## Attachment J - Comments on Addendum to DEIS

### Spoken Testimony on 145<sup>th</sup> Street Station Subarea DEIS Addendum

This Addendum to the DEIS is an important matter, and we are glad extra attention is being paid to the two major wetlands within the 145<sup>th</sup> Station Subarea. However, we have serious concerns about this report, especially the lack of adequate detail and inaccuracies presented as facts.

Figure 5: Twin Ponds and Paramount Park Wetlands and Streams

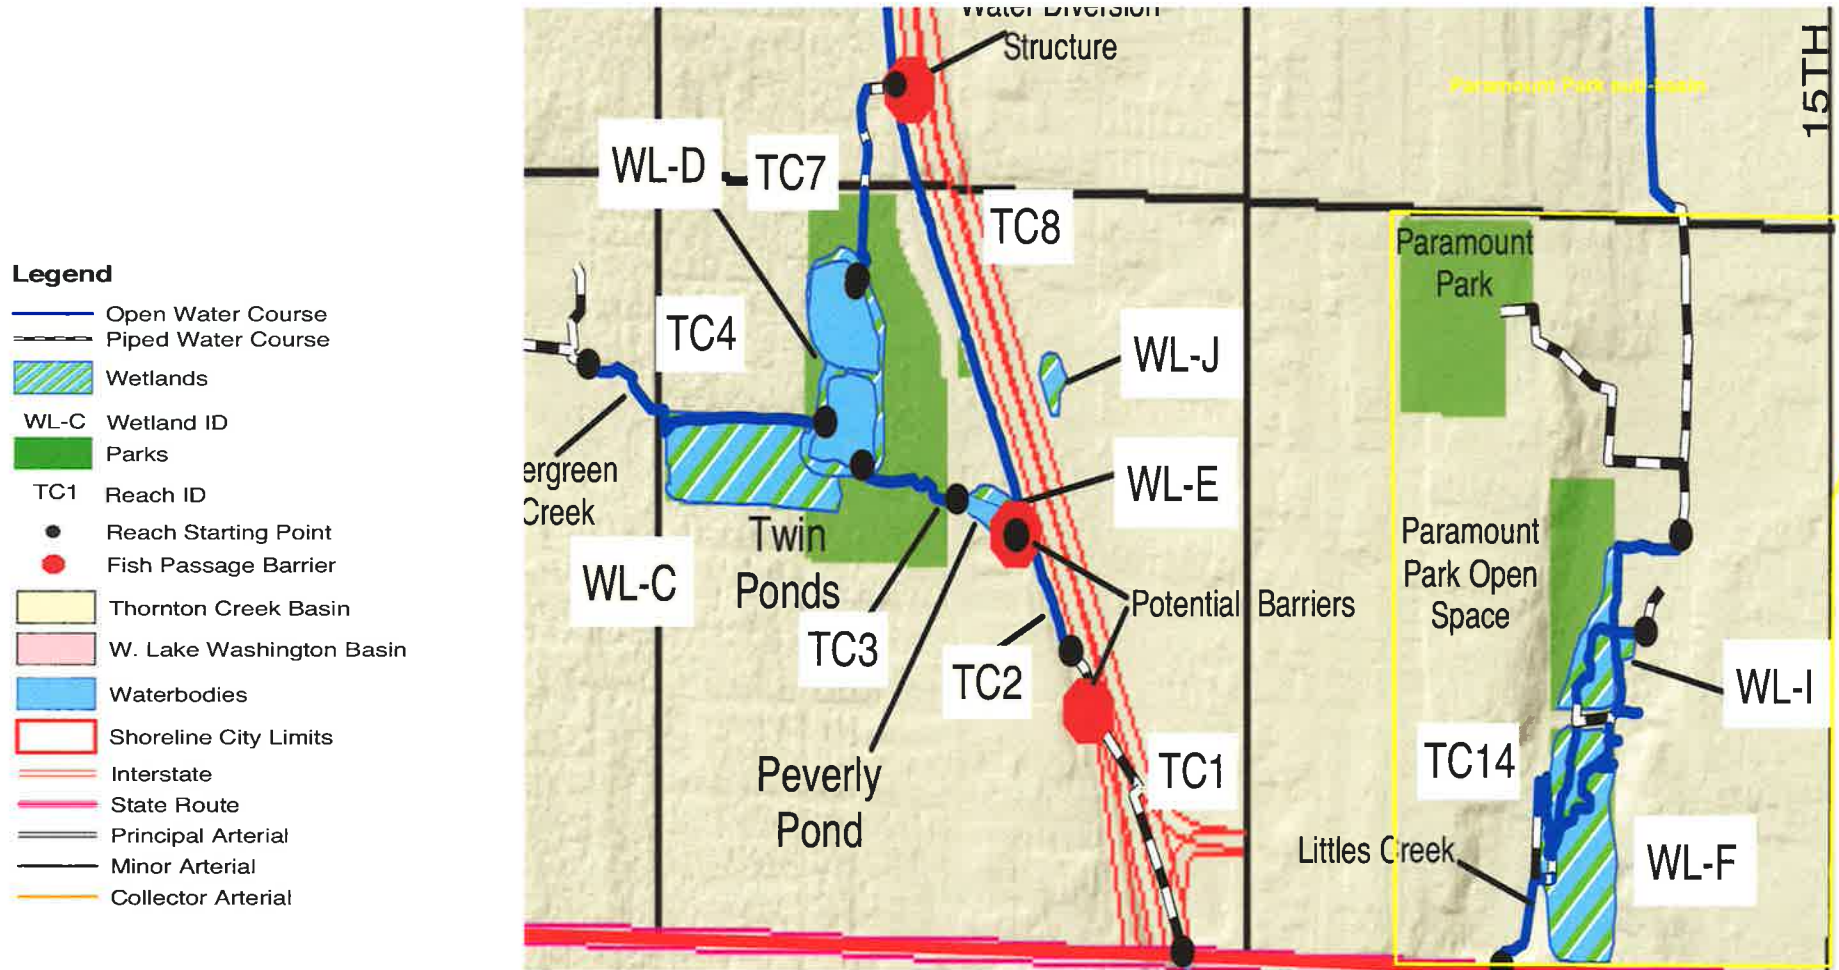
The two ponds and associated Wetland WL-F on Figure 5 were enhanced and/or constructed by local volunteers under a Water Quality Block Grant awarded by King county Department of Natural Resources prior to the 2004 basin characterization report. These areas are now well established and the plantings installed back in the early 2000's are now well established. Photos on photo sheet 6 of the attached photos show some examples of this area.

Little's Creek (Subbasin TC-C – Figure 3) flows through Paramount Open Space through segment TC14 mapped on Figure 5 as a tributary to Thornton Creek. The aerial photograph evidence documented in the City's Thornton Creek Characterization Report states that it flowed to Jackson Park in an open stream prior to the 1940's (Tetra Tech 2004). Much of this Creek has been piped from residences west of NE 174<sup>th</sup> Street and 14<sup>th</sup> Ave NE with another tributary that is now also flowing from a culvert. Beginning at 12<sup>th</sup> Ave NE, the creek (Figures 5 and 6) come out of a pipe and flow west to the Park and then jog south where the tributary splits into two. The western arm, which is the main channel of Little's

Creek, flows through Wetland WL-1 (2004 inventory, Figure 5) and a drainage tract with landscaping; and the eastern arm flows through on the edge of Wetland WL-L and through Wetland WL-F (also Figure 5 where it enters the pond and wetland enhancement area identified above supplying the wetlands, seeps back into the second pond via small channels described above and then flows west into the main channel of Littles Creek. The stream through the Park is generally still in good condition with sufficient bank vegetation and sparse armoring and fair pool frequency. Gravel and quarry spall is present in the south end of the reach but overall this segment is the ONLY one of the three segments of Thornton Creek within the City of Shoreline that was given a "fair" rating when assessed (Tetra Tech 2005). It is imperative that the City do all it can to maintain the integrity of these tributaries should the new zoning become reality. Increasing residence density on the east side of the Park would be in the direct path of many of these channels and no additional piping should be allowed. It should be noted that the DEIS states that Littles Creek lies ½ mile from the Proposed Light Rail Station, but actually it is only ¼ of a mile.

Figure 6: Paramount Park Wetlands and Streams Mapping. City of Shoreline GIS 2016.

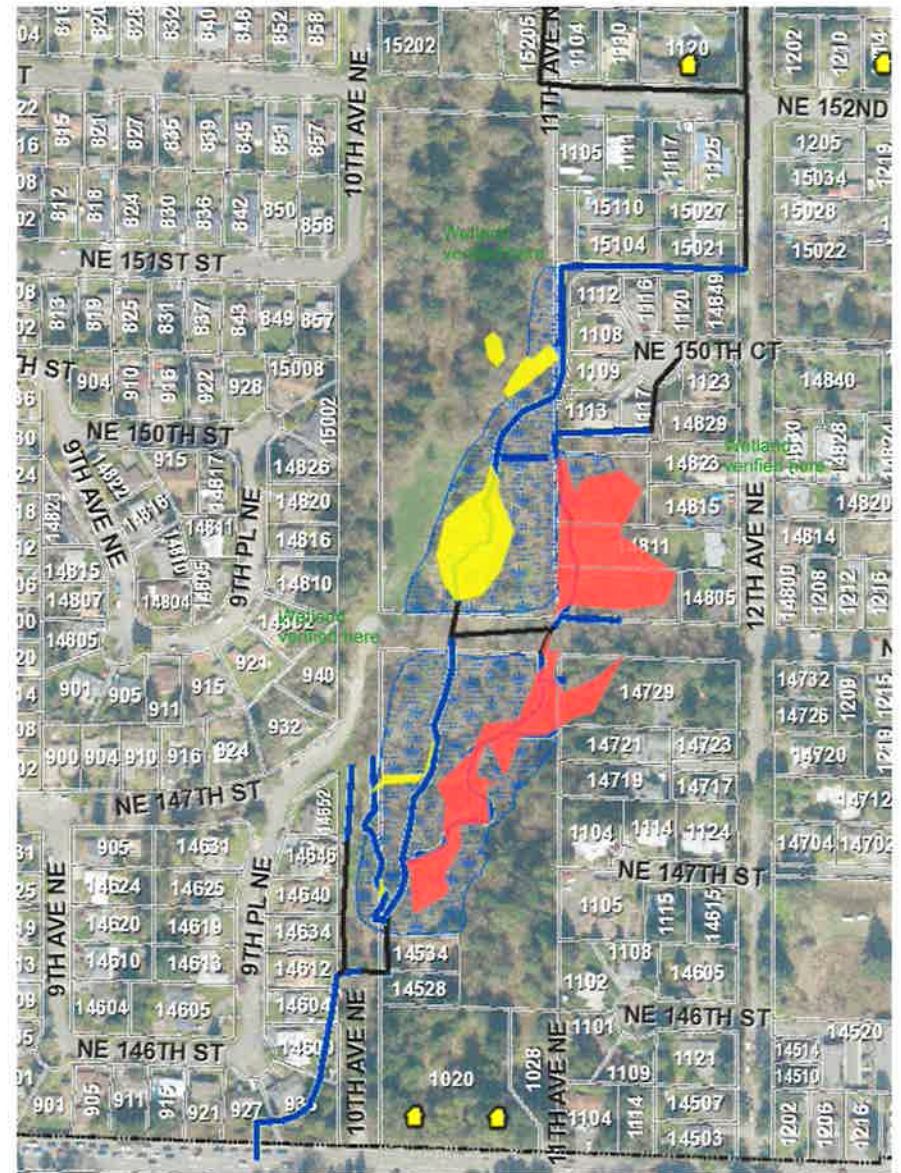
part of the park, (Figure 6 arrows showing where additional wetland was found; Figure 8 photo map and Photos 21-25). We also found more wetland in the northeast corner of the Park and associated residences that are not shown on the Otak map (Figure 6 arrows showing where additional wetland was found; Figure 8 photo map and Photos 1-10). And more wetland in the central part of the park between Wetland F and Wetland C such that these two wetlands are actually one wetland system (Photos P1, P2, P18, and P19). Additionally, many of the residences on the east side of the Park along 12<sup>th</sup> Avenue NE had wetland continuing into their western back yards abutting the Park (Figure 6 arrows showing where additional wetland was found; Figure 8 photo map and Photos 12-20). Much of this area was also not included as wetlands mapped by Otak. Approximate GPS locations of wetlands found during our February reconnaissance are shown on Figure 8 where the photo pins are located and on Figure 6 where the arrow points indicate locations where both photos and GPS points were taken in areas that were wetlands.. The arrows shown on Map 6 do not show a formal delineation map. It is indicating areas that met wetland criteria and which were not identified on the Otak map as being wetland. A word about the photos included: The photos show characteristics about the ground conditions – either the vegetation prevalent (which is usually wetland species for the wetland shots) or the soils conditions (again showing wetland soils), or standing water indicating the area has wetland hydrology. When the shots are of upland they indicate this.

The Otak reconnaissance wetland map is also displayed as a layer on the City's Wetland map as a layer that is shown as either a blue or yellow polygon/series of polygons on Figure 6. as the with Wetland III having a much reduced footprint of wetland WL-I and the red pattern with a much reduced footprint over the previous delineation also shown as the blue shaded pattern on Figure 6.

The drainages (streams and creeks) mapped in the Park by Otak (Figures 6 and 7) include some omissions that have been added back as the black lines on the City's GIS database (Figure 6). We observed these creeks/drainages are still present when we performed our reconnaissance on January 29<sup>th</sup>, 2016 (Photos P8, P9, P11, P17, P20, P23, P24, P21, and P25). Little's Creek is the main tributary to Thornton Creek through the park but there are many other tributaries, wetlands, ponds and connecting channels that are also present (See Figures 5 and 6). Some of the channels are now piped, especially the main channel that passes through a culvert under the gravel road the bisects the Park from north to south (photo P17).

**Figure AW-1**  
**Critical Areas - Paramount Park**  
 Critical Areas Memorandum  
 Draft Environmental Impact Statement  
 145th Street Station Subarea Plan  
 City of Shoreline, WA

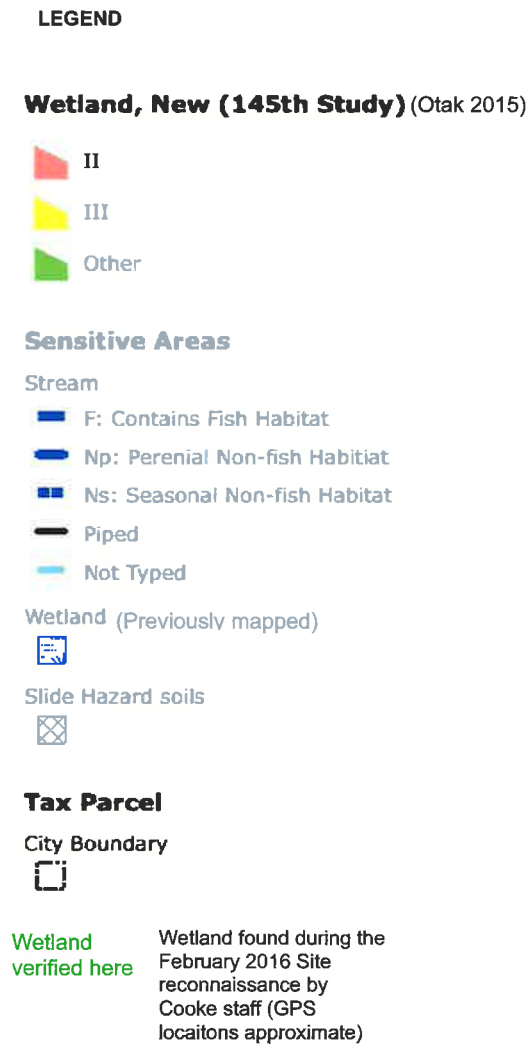
We would also note that Figure AW-1 in OTAK's report, "Critical Areas – Paramount Park," does not, in fact, seem to substantiate the report's claim that there are currently structures actually located in the wetlands that extend out from the park. Certainly no houses appear to be in the wetlands. There are six houses along 12<sup>th</sup> Avenue Northeast that are within wetland buffers, but in five of these cases all or essentially all of the parcel is inside the buffer and in the other case far too little of the parcel is outside the buffer to be developable. This means that reasonable use requirements would almost certainly still

**Figure 7: Paramount Park Wetlands and Streams Mapping, Otak 2015**

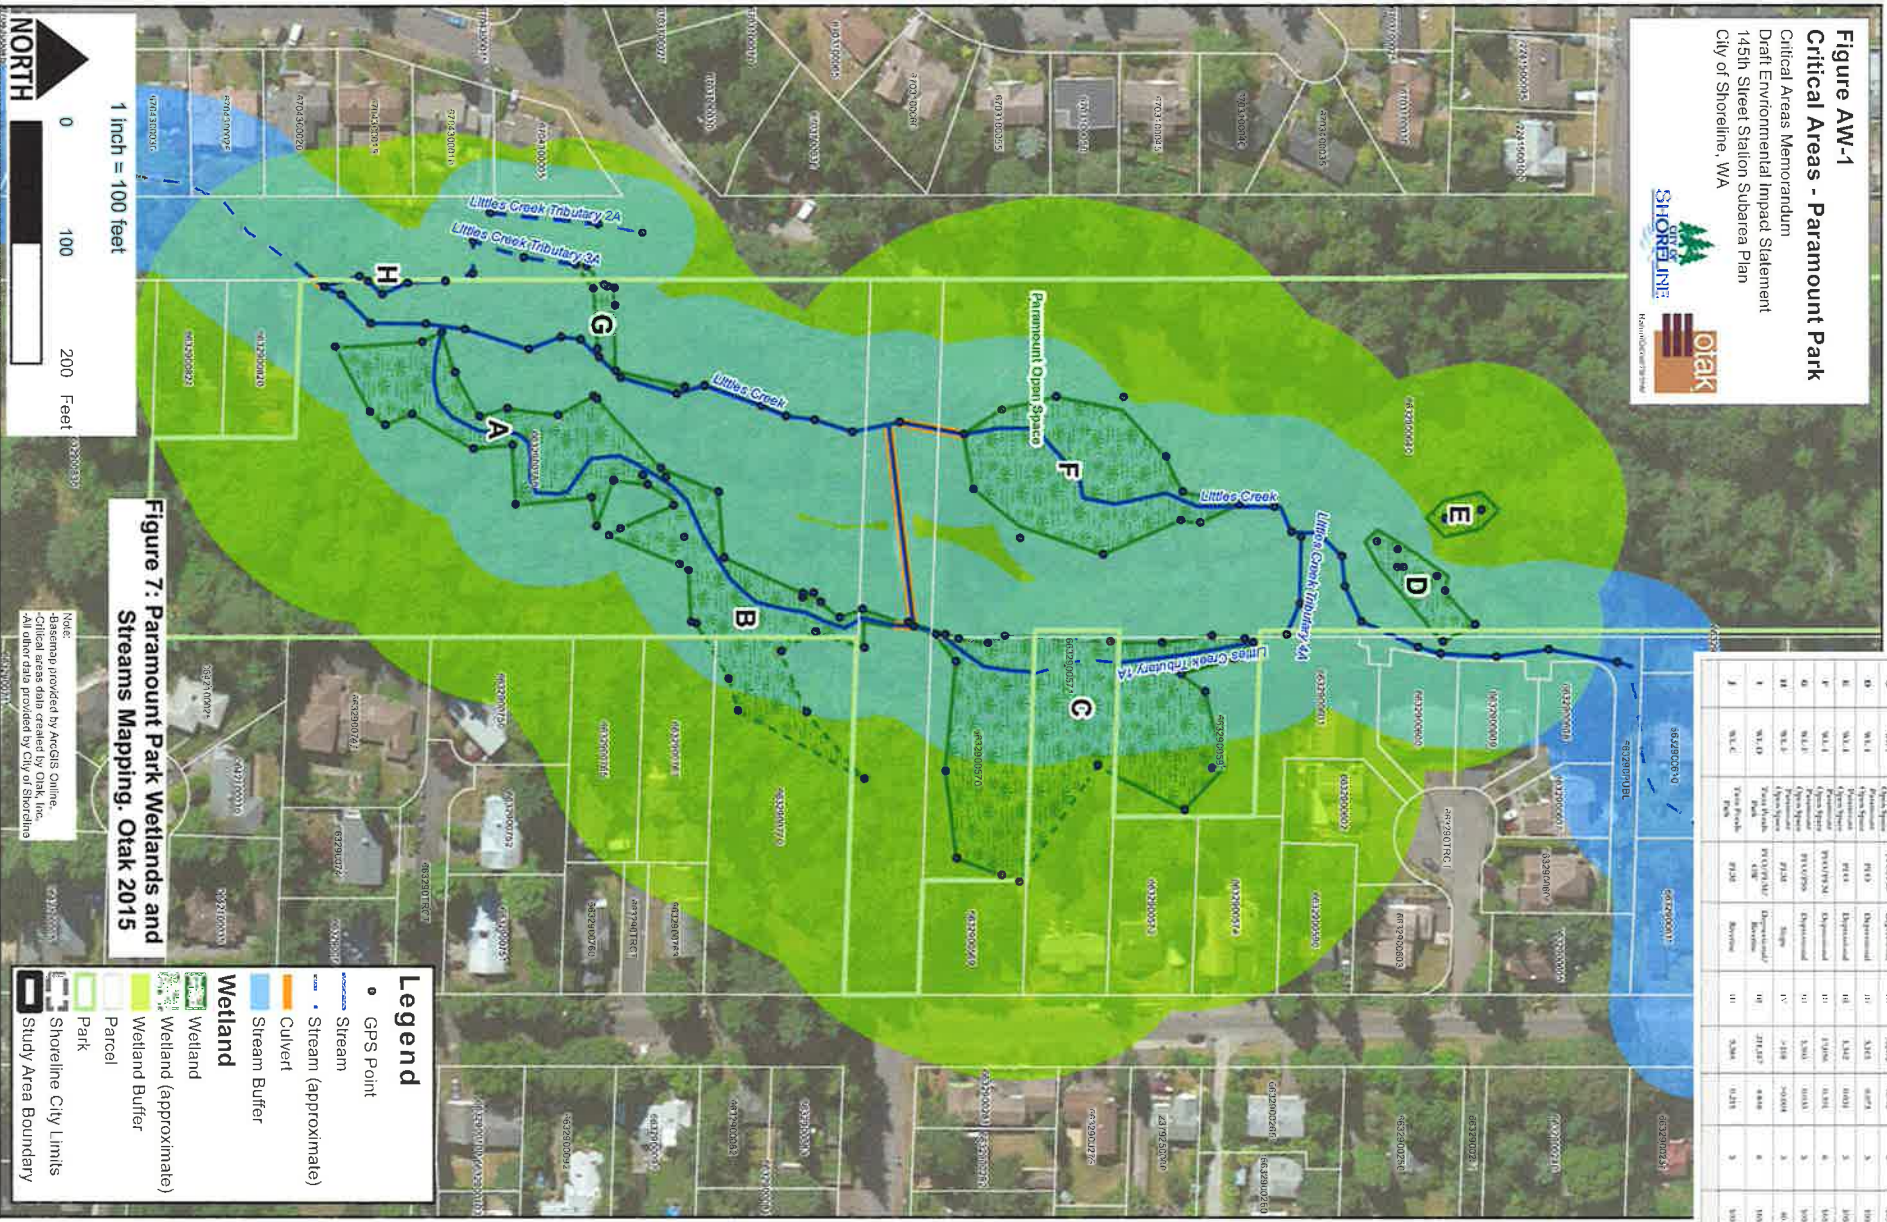
The wetland ratings listed in the Otak reconnaissance from August and September 2015 were all listed as Category III and IV wetlands (see table at top of Figure 7), while the City's wetland inventory reports 4 Category (type) II wetlands and 5 category (type) III wetlands within the Park and three Category (type) II wetlands and 1 Category (type) III wetland just adjacent to the Park. While I did not rate the wetlands during my site evaluation it should be noted that I sat on the team that developed the 1992 wetland rating and I was a technical reviewer and taught the method for the Department of Ecology for the subsequent version (2004 updated in 2008) used for this analysis and I find it unlikely that some of the forested wetlands I saw out in the Park would be less than a Category II wetland rating. The rating should be revisited when a formal delineation is performed because the buffer widths proposed could possibly change as a result of the ratings changing from a Category III to a Category II wetland. This would obviously affect the development footprint on the lots just adjacent to, or including the wetlands that would be a Category II type. The buffer widths assigned to the

In the 2000 and 2004 Thornton Creek reports by the City of Seattle and Tetra Tech for the City of Shoreline including stream inventory (Appendix A May 2004), and the City's own GIS database (Shoreline online GIS Mapper) all show the streams to be mapped as shown on Figures 5 and on Figure 6, (the overall outline including both the blue and black segments). Figure 6 also shows the seam/creek reconnaissance identified by Otak in their December 2015 reconnaissance as the blue segments with the detailed stream reconnaissance shown on Figure 7.
